MIL-E-23001/3D(AS)
AMENDMENT 1
25 March 1977

MILITARY SPECIFICATION SHEET

ELECTRIC GENERATING SYSTEM, AIRCRAFT, VSCF
20 KVA, 115/200 VOLT, 3-PHASE, 400 Hz

This amendment forms a part of Military Specification Sheet MIL-E-23001/3D(AS), dated 25 July 1975.

Figure 1

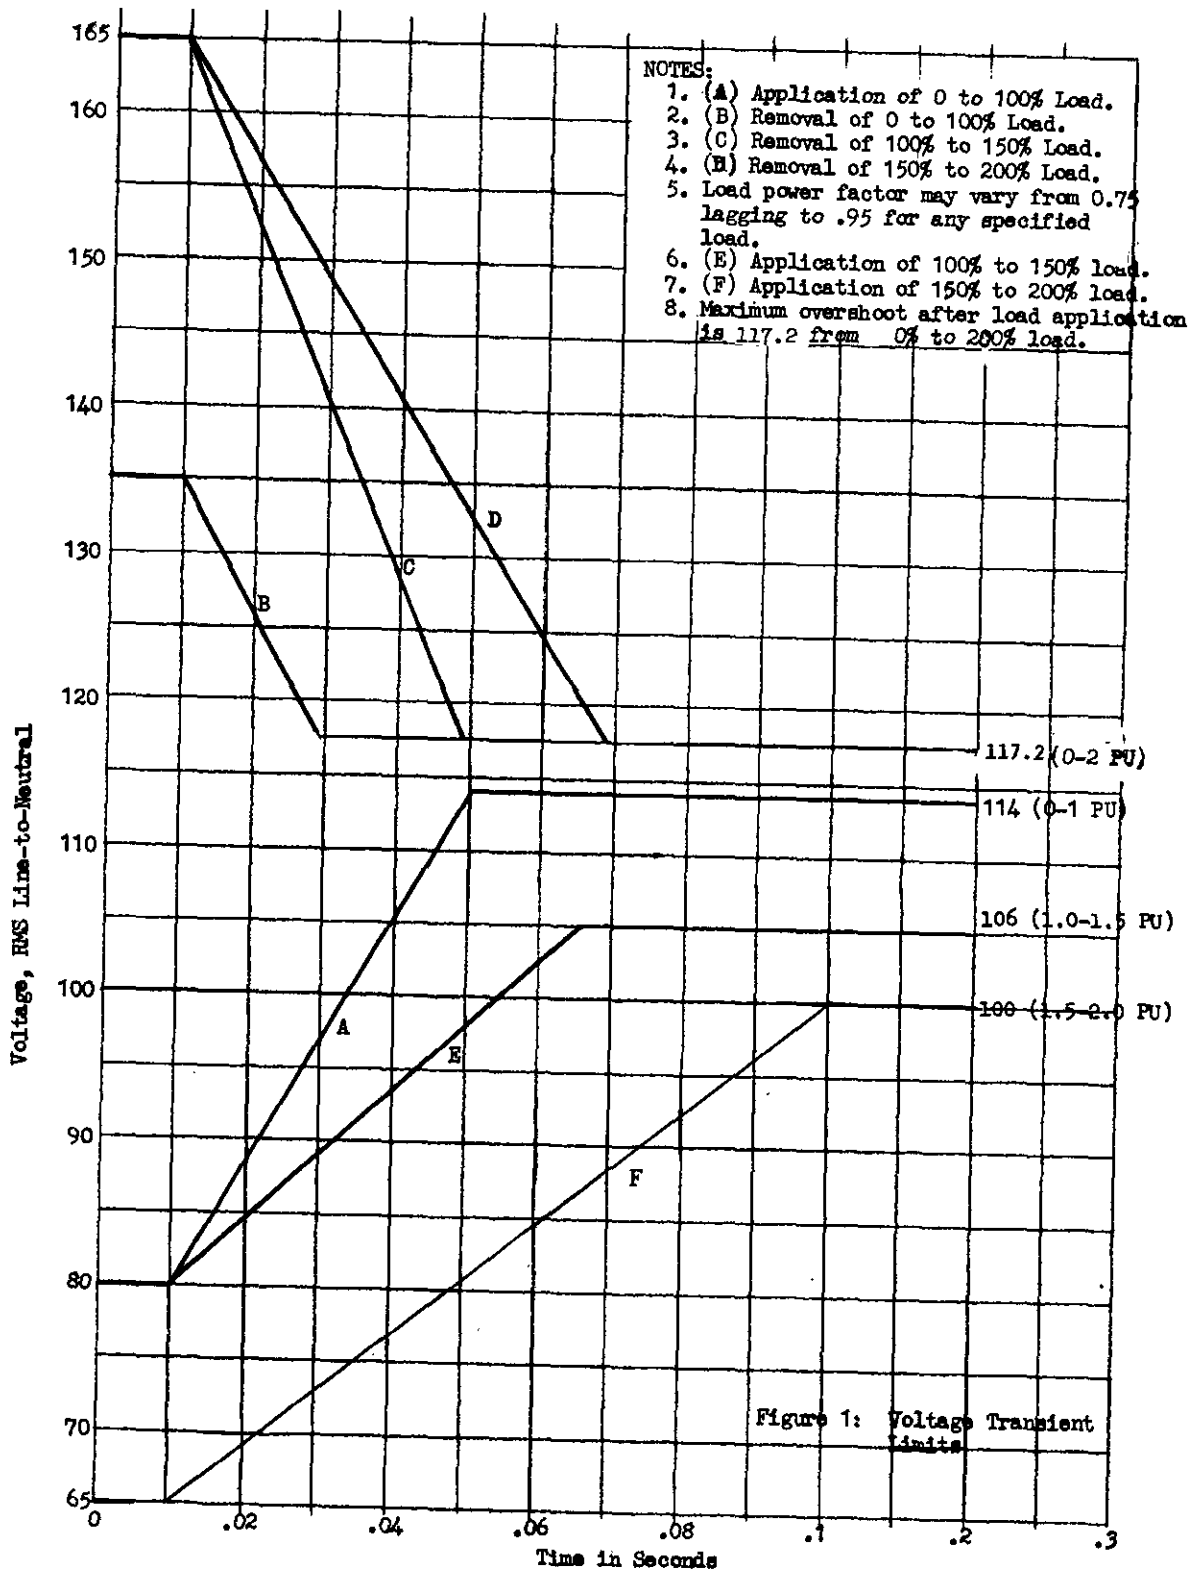
3.2.2 Add: "Curve F of Figure 1 of this amendment shall be modified to be zero volts from 0 to 2 seconds, after which time it goes directly to 100 volts."

Delete and substitute Figure 1 of this amendment.

Figure 5
Filter Characteristic
for measuring
Voltage and Frequency
Modulation

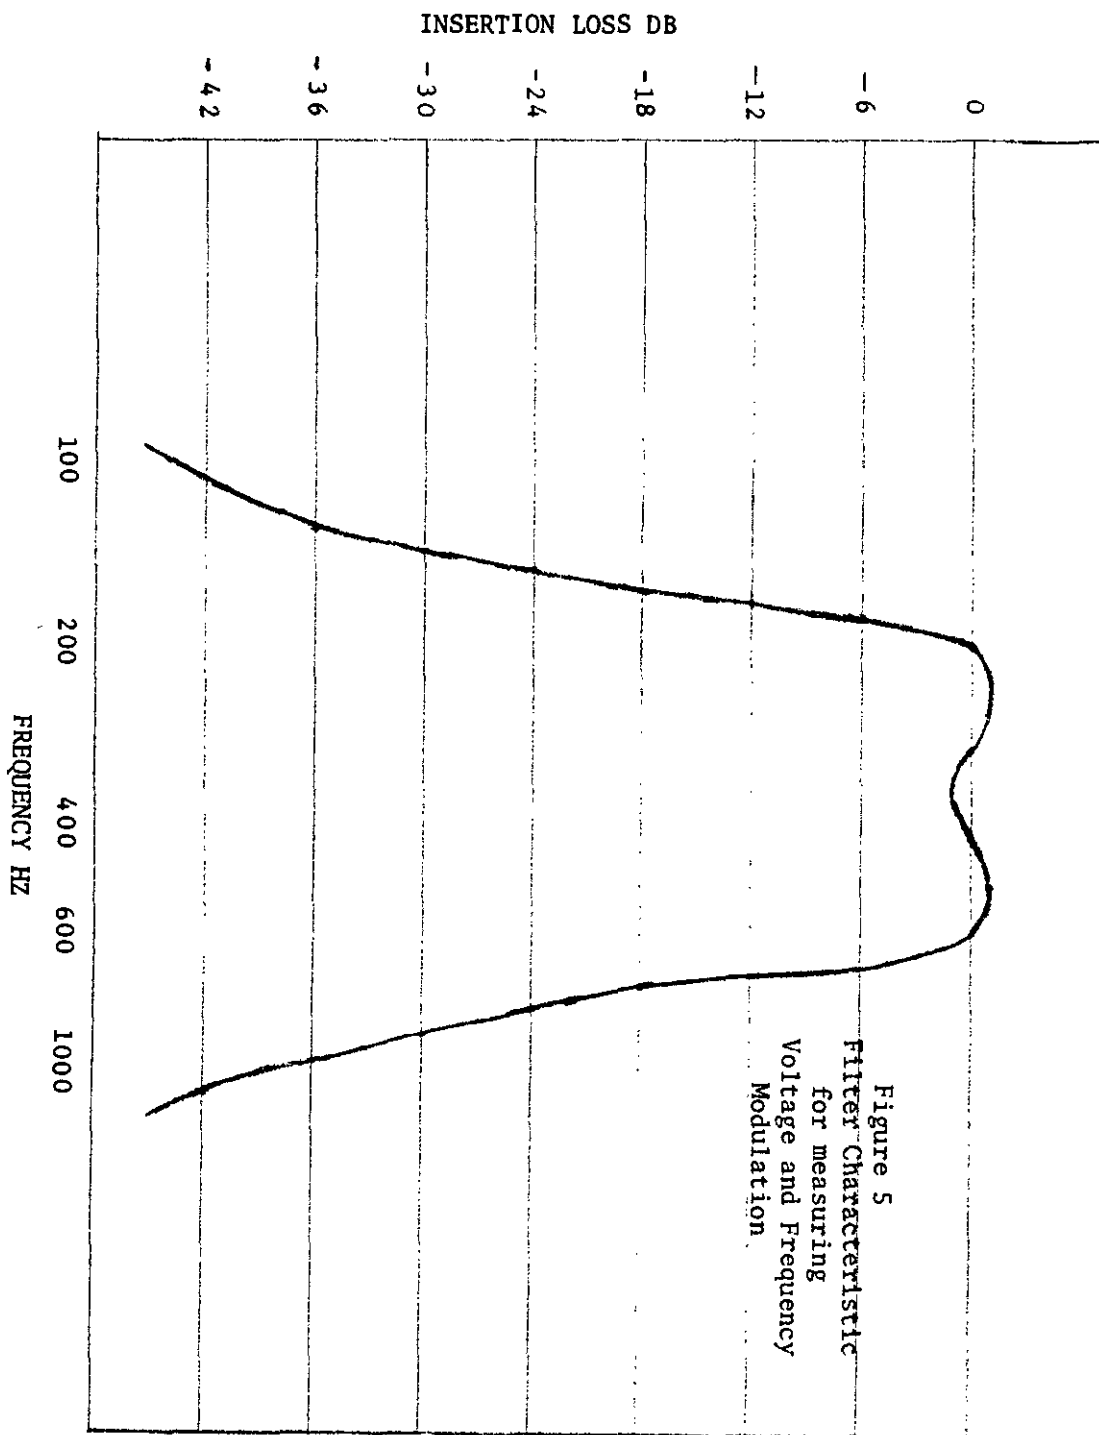
Add: 4.5.9 Voltage Modulation, Frequency Modulation, and Waveform. Delete "low-pass" and substitute "band-pass" in second sentence. Delete Figure 5 and substitute Figure 5 of this amendment.

Generator Mounting Plate

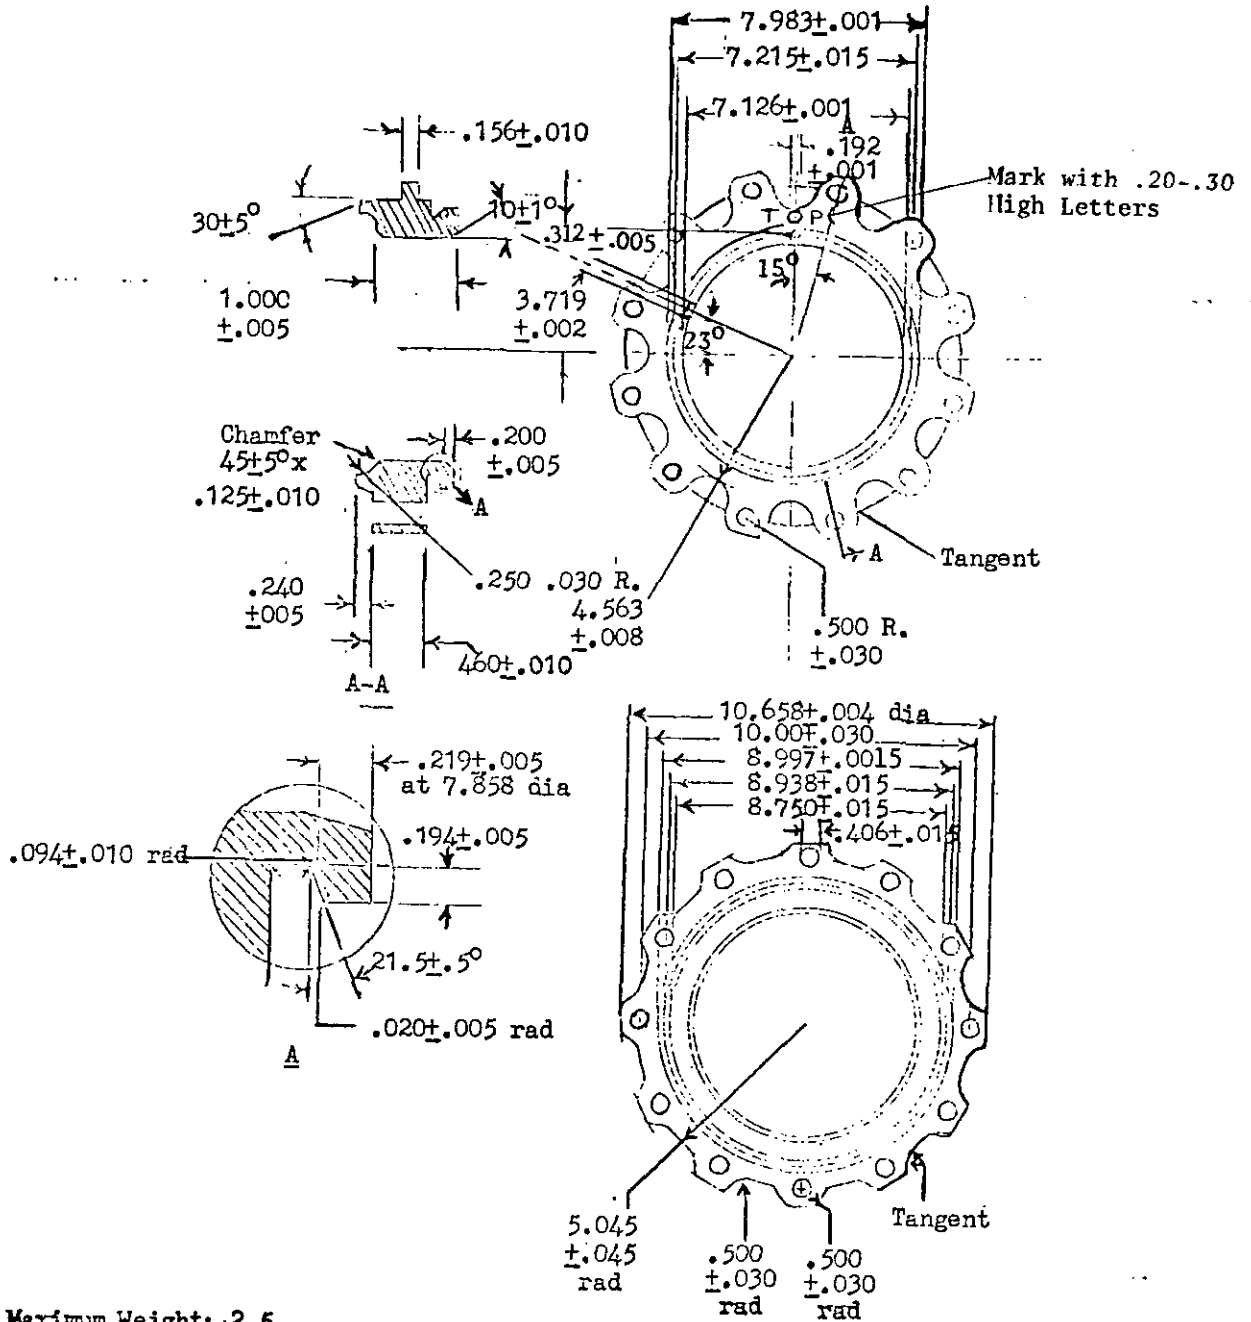
4. Generator Mounting Plate and Quick - Attach-Detach Clamps.
Delete and substitute: "A mounting plate (P/N M23001/3-10) conforming to page 9 of this amendment shall be used. A mounting clamp (P/N M23001/3-11) suitable for mounting the generator to the mounting plate when the mounting plate is installed on a drive pad conforming to AND20006, Type No. XVI-A, and contained within a circle having a diameter of eleven inches and concentric with the mounting plate, shall be used. The generator mounting clamp shall not be of sheet metal construction and not exceed 1.5 pounds in weight.
